1998 - 2002 Corvette: Service Bulletin: Audible Spark Knock (Detonation), MIL Illuminated, DTC P0332 Set

Subject: Audible Spark Knock (Detonation), MIL Illuminated, DTC P0332 Set
(Replace Rear Bank Knock Sensor and RTV Area Around Sensor)

Number: 02-06-04-023

Models: 1998-2002 Chevrolet Camaro, Corvette, 1998-2002 Pontiac Firebird with 5.7L Engine (VIN G -- RPO LS1)

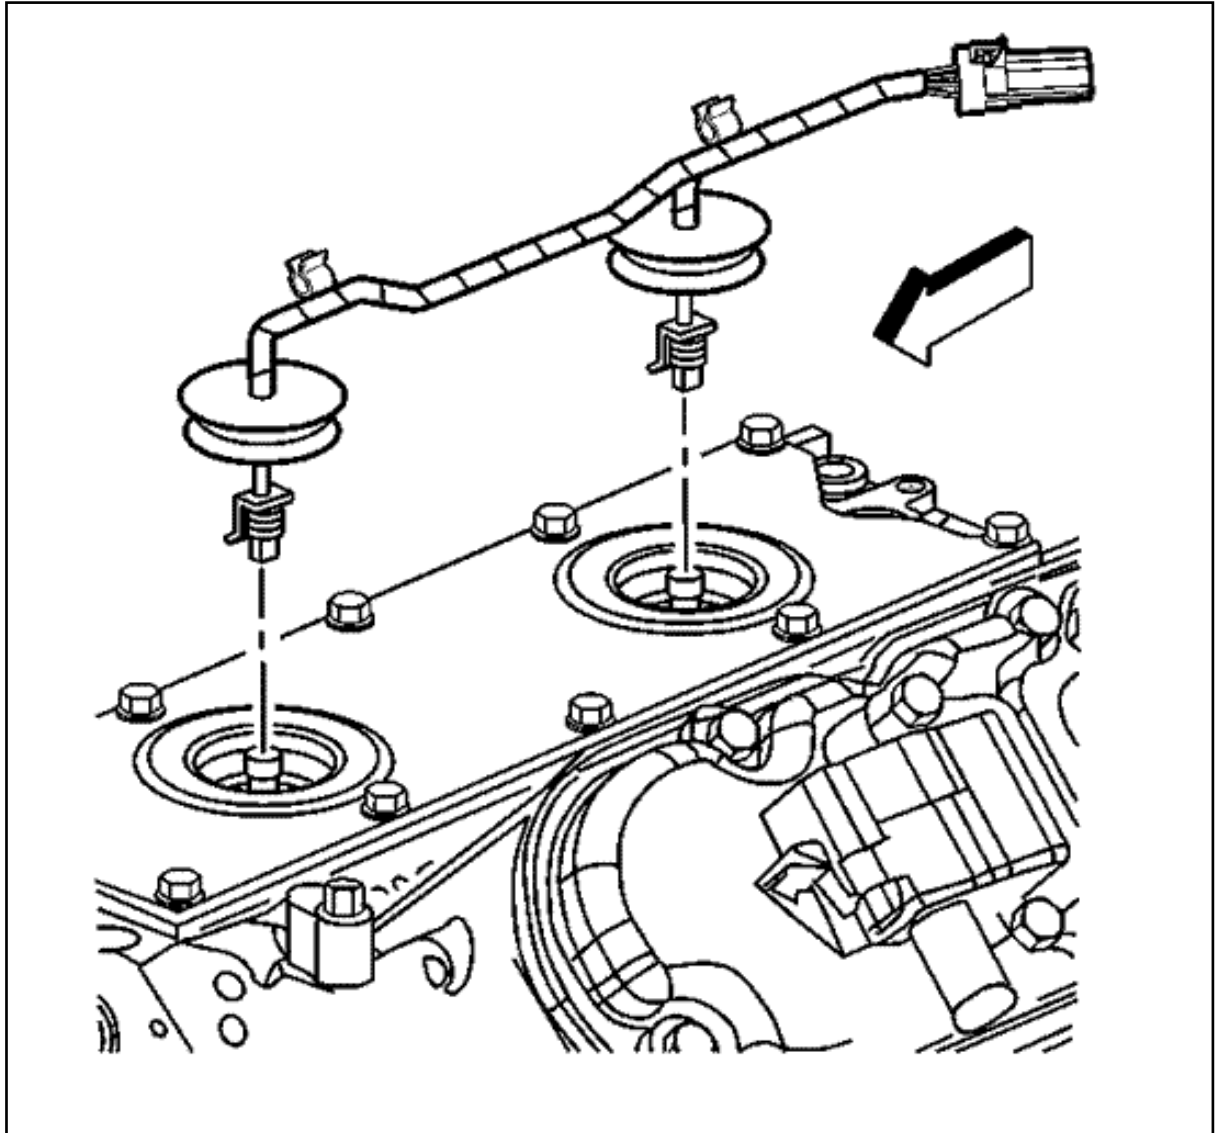
This condition may be the result of corrosion of the rear bank knock sensor due to water intrusion into the sensor cavity. This condition is more apparent on vehicles in which customers frequently wash the engine compartment.

Replace the rear bank knock sensor and build a dam (wall) around the sensor using RTV to divert water away from the sensor. Use the procedure and part number listed below.

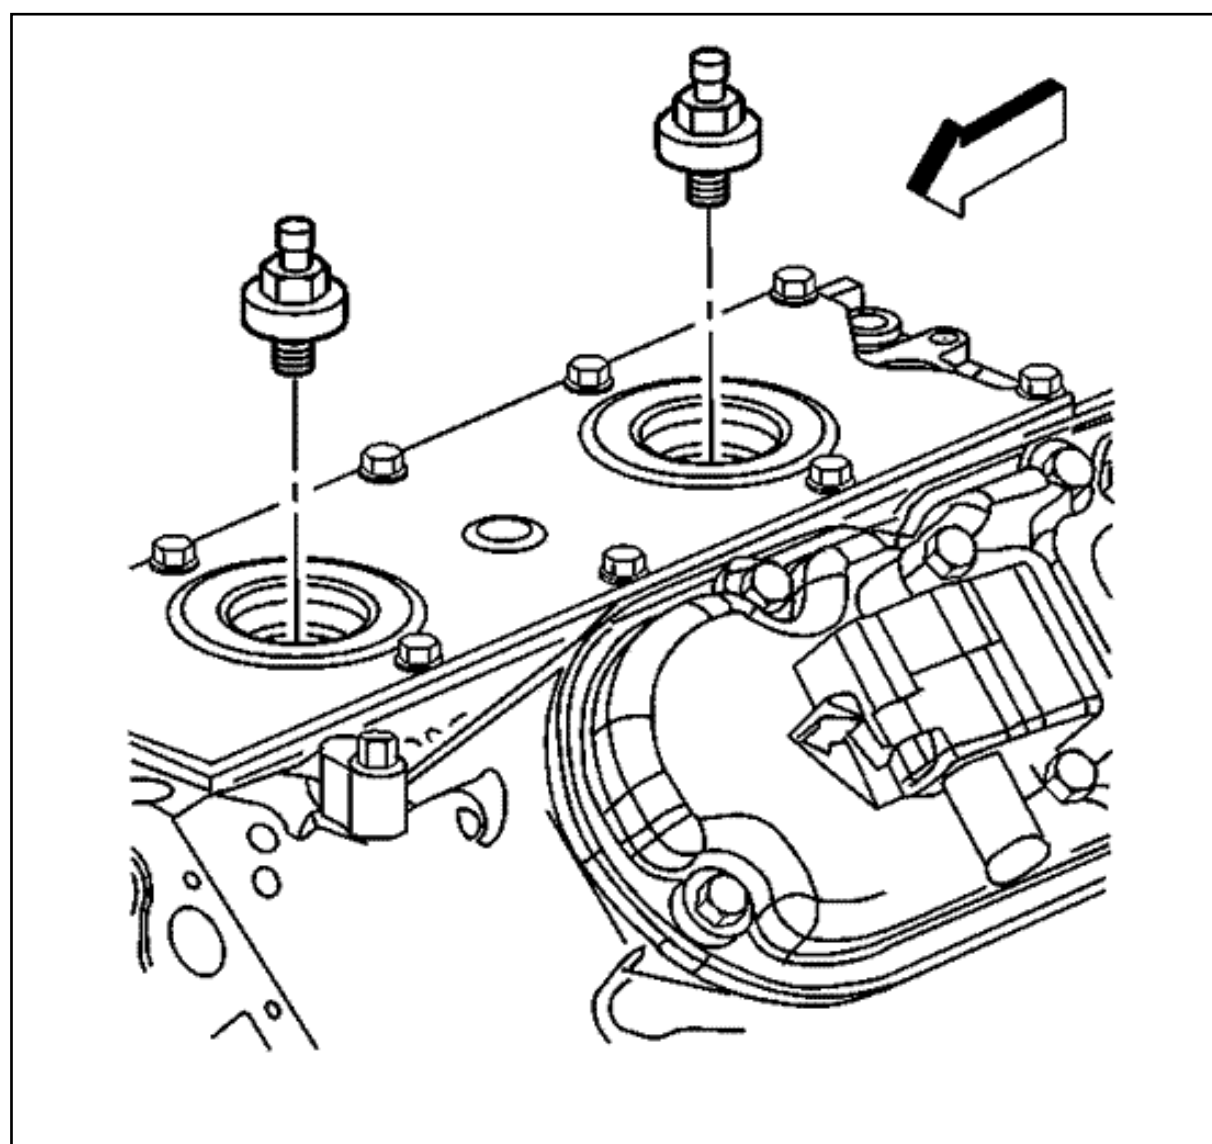
- Remove the wiring harness assembly from the knock sensor.

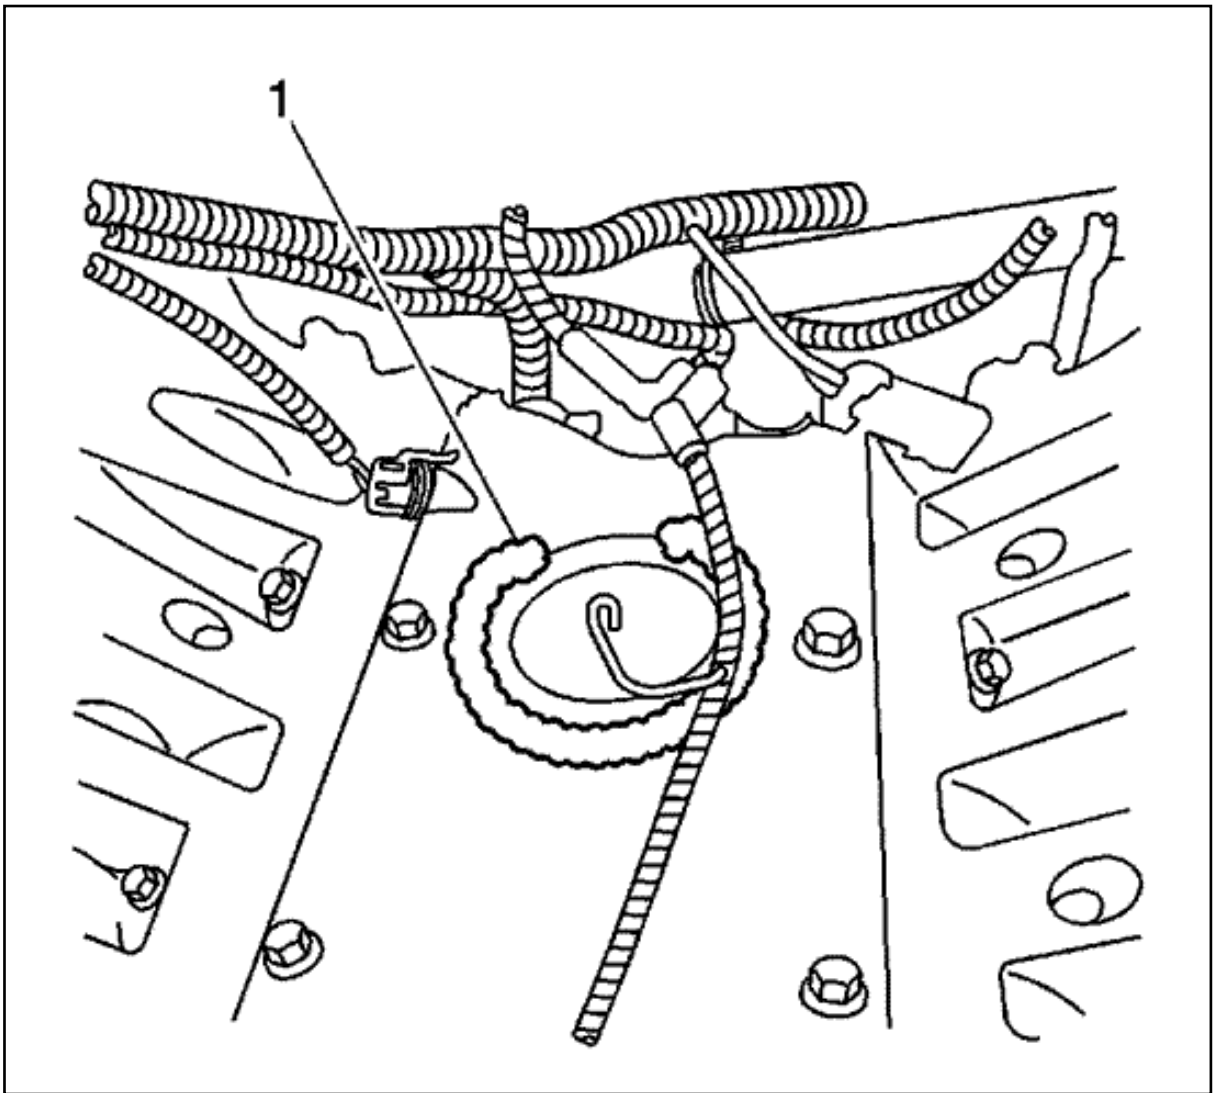
- Remove the rear bank knock sensor.
- Install the new rear bank knock sensor. **Tighten** the knock sensor to 20 N·m(15 lb ft).
- Install the wiring harness assembly to the knock sensor.

- Apply a bead of RTV silicone sealant approximately 9 mm (3/8 in) wide and 6 mm (1/4 in) high along the outside edge of the ridge on the engine block valley cover around the rear bank knock sensor. DO NOT form a complete circle. Leave the rear section open as shown.
- From the underside of the intake manifold, completely remove the
